**Resource consent application – Further information request**

Application number(s):	BUN60444618 (DIS60444619 and LUC60444660)
Applicant:	Vernon Developments Limited
Address:	1799A Great South Road, Drury
Proposed activity(s):	Rural commercial service / rural industry with associated stormwater discharge and earthworks on a site in the Mixed Rural zone

Stormwater and ITA

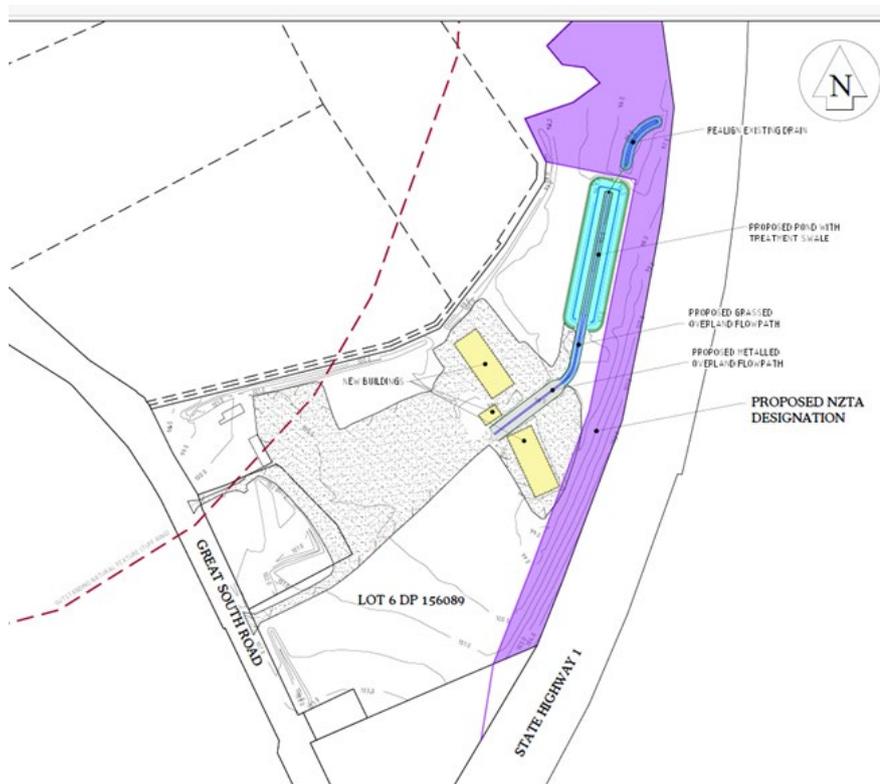
- 42 It is understood that all storage of diesel (and any other hazardous substances) as well as the maintenance and repair of machinery used for Aaron's contracting business will be carried out in the sheds and wash down area in the central portion of the site, rather than in the north-western portion of the site that is earmarked for Aaron's contracting. Please confirm.

- 43 It is noted that this site has been stated not to be a 'goods' site, please confirm that vehicles stored on this site will not temporarily be holding goods on site, such as stock feed, fertiliser, aggregates or other raw materials.

- 44 Due to the range of activities supported by the vehicles brought to site, it is considered that contaminants of concern may be tracked to site and accumulate on the hardstand/parking area over time. Please identify any known contaminants of concern from these activities, and how these will be managed by the proposed stormwater management provided.

- 45 It appears that stormwater from 'Aaron's Contracting' will also be draining via the proposed stormwater management system. This application for ITA does not include assessment of the activities carried out by Aaron's Contracting. How will liability be managed between sites, if non-compliance with discharge conditions is found?

- 46 The Council specialist agrees with the applicant that the ITA for this site is a moderate risk and considered a permitted activity for land use. However, standard E33.6.1.2 is not considered to be met. As such the discharge would be considered as a controlled activity under E33.4.2(A18). Please apply for the required s15 discharge permit through the Council portal.

The concrete wash pad is considered an ITA area, and the refuelling area may also be considered a contaminant generating area. Please provide these areas on a plan.

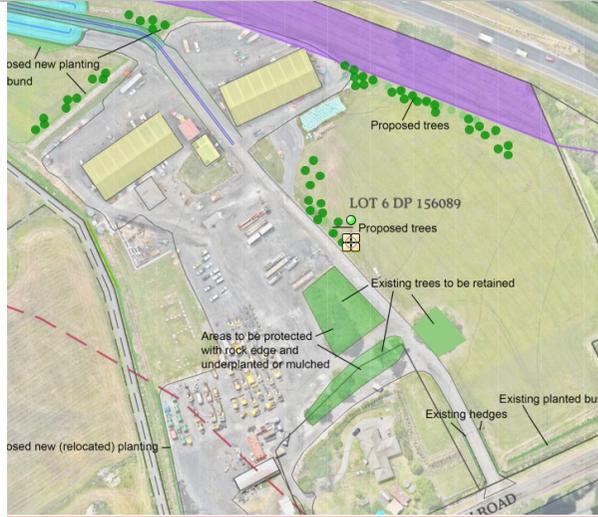
9	Please clarify whether the anticipated 30 staff members are only for the rural contracting component of the business, or whether administrative staff on site will be involved in all business components operated under the umbrella of Vernon Developments?	Responded to.
10	<u>Signage</u> Existing signage displaying messaging associated with the business activity is currently being displayed near the motorway boundary ('Dig it, move it, recycle it, AG it). Please confirm what is intended with regard to these signs and whether consent is being sought as part of the current application.	If the signs are not included in the RC application, please confirm how the referenced signage is being authorised? <i>Note: the office building appears to be building work associated with the proposed activities. This</i>

No	Requested Information (2 <sup>nd</sup> April 2025)	Resolved/Outstanding
	<p><i>Note: The 'bull head' would be considered artwork which is permitted under the AUP(OP).</i></p>	<p><i>may meet the \$100,000 threshold for comprehensive development signage.</i></p>
11	<p><u>Highly Productive Soils</u></p> <p>The AEE on Page 30 states that imperfectly drained 3s3 soils on the site are classed as other productive land under the AUP(OP), not prime land. However, as per the AUP(OP) definition of 'Land containing prime soil', all LUC 2 and 3 soils class as prime soils under the AUP(OP). Please update your assessment accordingly and provide a revised AEE, to avoid later confusion.</p>	<p>Response noted but not agreed with.</p>
12	<p>The AEE states on page 15:</p> <p><i>VD has a broad rural production client base. Their clients include large arable cropping business and members of the Pukekohe Growers Association such as R C Hari Ltd, Balle Bros Ltd and Manga Jivan Ltd. Forestry clients including JT Logging and Pulley Contracting Limited. Intensive and pastoral farming clients include pig, poultry, goat, dairy and drystock businesses. While the primary function of VD is to service the rural production sector, a small amount of work is also undertaken for residential and commercial clients. This is to ensure that the business is diverse enough to handle the seasonal nature of farming and to ensure all staff remain employed throughout the year. It is expected that the activity will grow to employ 30 staff over the next 5 -10 years. The site will provide an administration hub and storage yard for staff, vehicles and machinery (...).</i></p> <p>This description of the business activities appears to go beyond a supporting activity, as defined in the NPS:HL (see non s92 commentary). If you consider otherwise, please provide additional information to demonstrate that the proposed activities support land based primary production on the site, surrounding HPL and the applicants' landholding.</p>	<p>Response noted but not agreed with.</p>

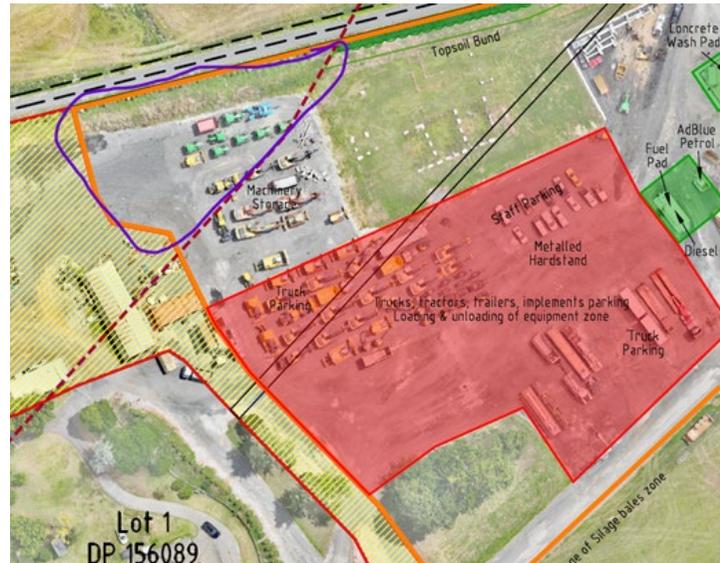
be entering the site and directed to the new pond. If this is the case there will be altered catchments to existing OLFPs. Please confirm that the pond is sized to attenuate all contributing catchments.

49 Please confirm how stormwater from the site earmarked for Aaron’s contracting is proposed to be diverted to the proposed stormwater pond, as this part of the site appears to be draining to the west currently.

Thank you for confirming 3,900m2 will be outside the pond catchment area (including a large portion of Aarons consulting). Are any proposed treatment measures for this area or management of the stormwater quality to be provided for this area? Please provide further information as to why the 'machinery storage' area sits outside of the 'high contaminant carpark' and outside an ITA area, in comparison to the adjacent hardstand (Blue area circled in the figure to the left).
